Access Compliance Report

Public Rights-of-Way

(Curb Ramps)

Intersection ID: 12170	Main Street: S_POPLAR_ST	Cross Street: W_4TH_ST	Location:	W
ADA ID: 882B4DF786D1	Ramp Type: PerpDiag	Initial Pass/Fail: Fail	Overall Compliance: No	Severity Score: 10
Codes/Mitigation Info/Possible Solution		Field Measurements/Component Compliance

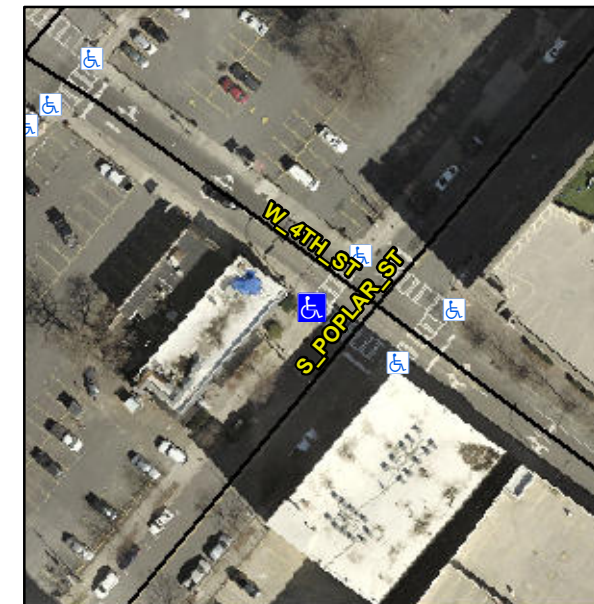
R304.5.1, R304.5.3

Compliance	Description	Data	Compliance	Description	Data
N/A	Ramp Length (in)	114.0	Yes	Ramp Slope (%)	5.6
No	Ramp Width (in)	47.5	No	Ramp XSlope (%)	4.1
N/A	Flare Type LT	N/A	N/A	Flare Type RT	N/A
N/A	Flare Slope LT (%)	N/A	N/A	Flare Slope RT (%)	N/A
N/A	Flare Traversable LT?	N/A	N/A	Flare Traversable RT?	N/A
N/A	Landing Length (in)	N/A	N/A	DWS Provided?	N/A
N/A	Landing Width (in)	N/A	N/A	DWS Contrast?	N/A
N/A	Landing Slope (%)	N/A	N/A	DWS Length (in)	N/A
N/A	Landing X Slope (%)	N/A	N/A	DWS Full Width?	N/A
N/A	Landing Curb? (Y/N)	N/A	N/A	DWS Offset (in)	N/A
N/A	Shared Landing?	N/A			
N/A	Gutter Ponding?	N/A	N/A	Gutter Slope (%)	N/A
N/A	Gutter Lip Ht (in)	N/A	N/A	Gutter X Slope (%)	N/A
N/A	Painted X Walk1?	Yes	N/A	Painted X Walk2?	Yes
	X Walk 1 Direction	To SE		X Walk 2 Direction	To NE
N/A	X Walk 1 Width (in)	113.0	N/A	X Walk 2 Width (in)	113.0
	X Walk 1 Slope (%)	1.5		X Walk 2 Slope (%)	3.0
	X Walk 1 X Slope (%)	5.2		X Walk 2 X Slope (%)	0.8

N/A	Ramp inside XWalk1?	Yes	N/A	Ramp inside XWalk2?	Yes
	Road Slope (%)	3.8	N/A	Clear Space?	N/A
	Road X Slope (%)	3.0	N/A	Clear Space to XWalk (in)	N/A
N/A	Any Obstructions?	N/A	N/A	Storm Grate/Utility Hazard?	N/A
	Obstruction Type			Storm Grate/Utility Type	
		N/A			N/A
		Yes		Surface Condition? (G/P)	Good

Remove & Replace Curb Ramp With Two New Directional Ramps or Equivalent.
